Environmental Assessment of Ground Water Compliance at the Slick Rock, Colorado, UMTRA Project Sites

Final

February 2003

| Appendix A. Comments Received on the Draft Environmental Assessment and Responses to Comments |

Figure 5. Monitoring Locations at the Slick Rock UC Site

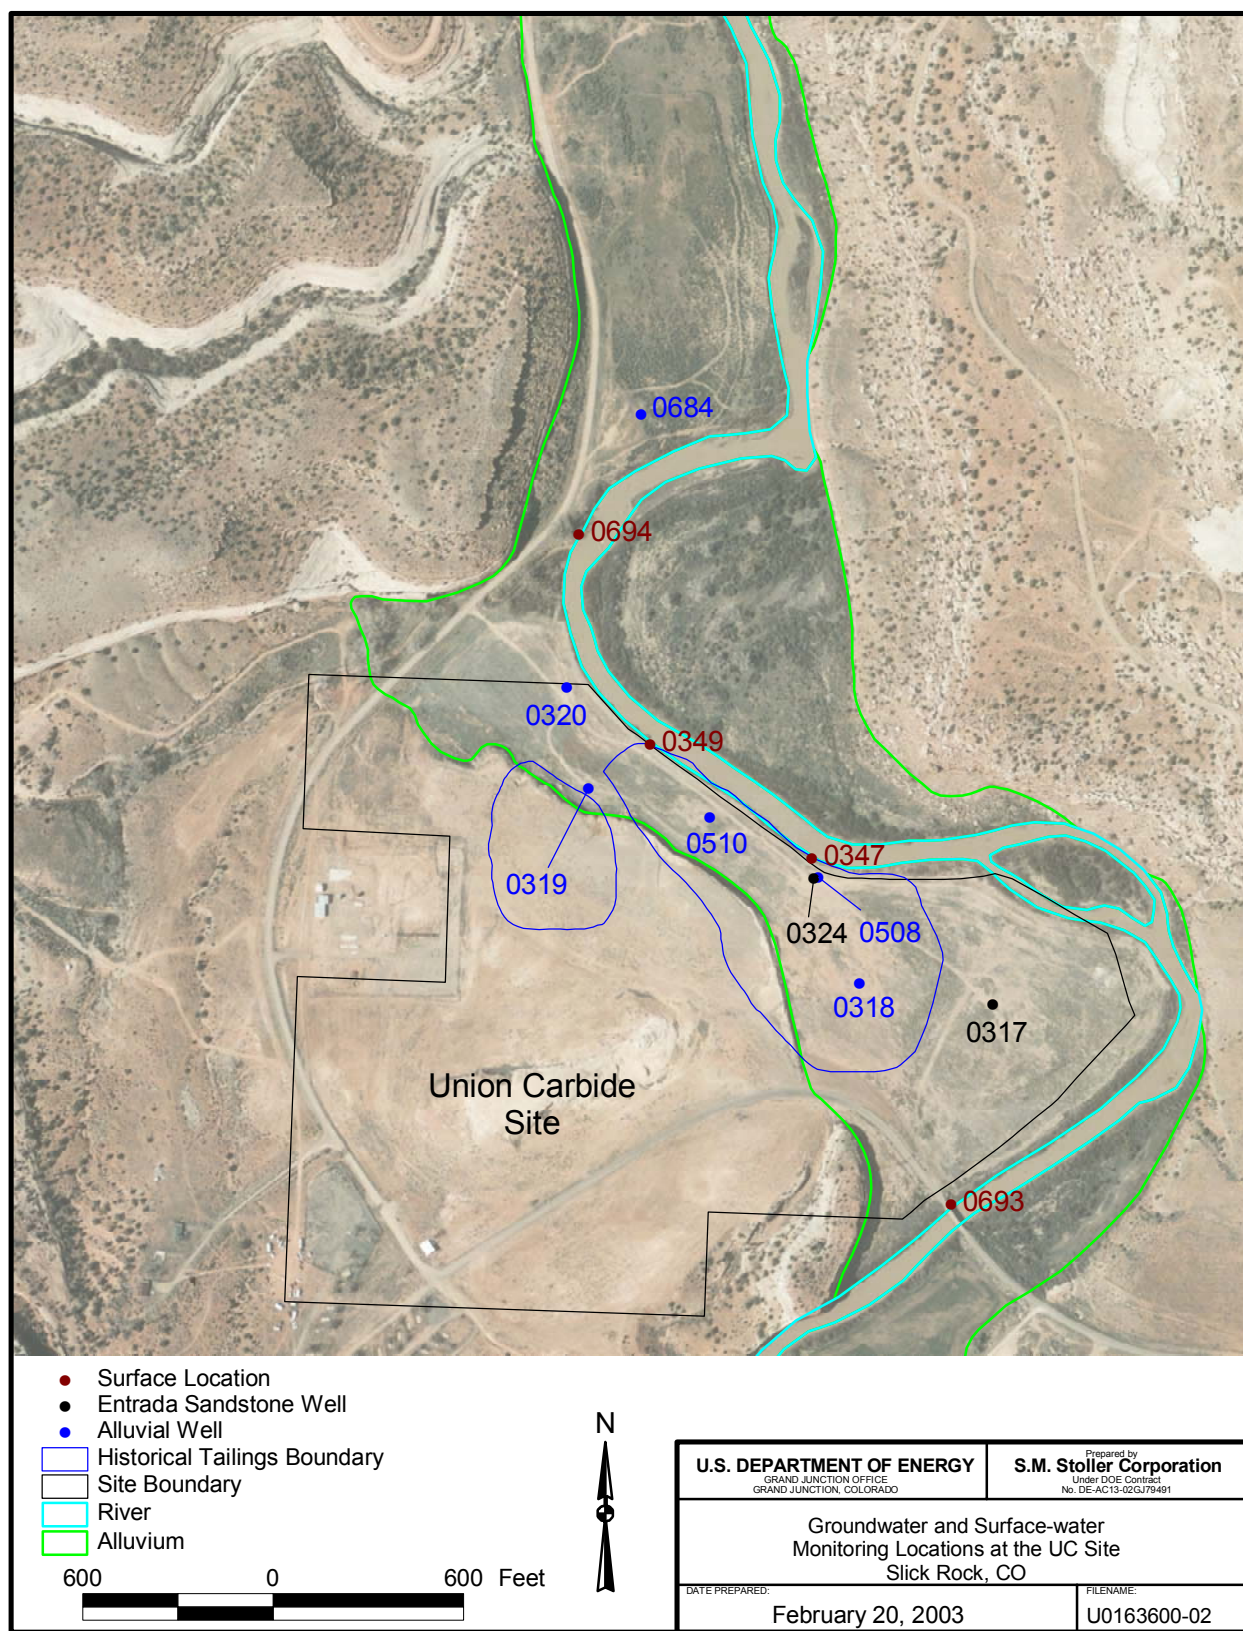
Page 14. Although the number and placement of the 11 monitoring locations within the UC site is commendable, the addition of two additional ground-water wells north of the UC site would provide improved monitoring of plume movement.

Response to comment concerning off-site migration of COPCs: The EA states that none of the contaminant plumes have migrated off the Union Carbide site to date. This statement is based on monitoring results from alluvial monitor well 0320, which is located on site and immediately downgradient of the contaminant plumes. Concentrations of COPCs in samples collected from well 0320 have been significantly below their respective water quality benchmarks. Ground water monitoring results from well 0320 will reflect future plume migration because there is no ground water flow scenario where the plumes could bypass this well. Monitor well 0320 is scheduled for long-term monitoring to track contaminant plume movement.
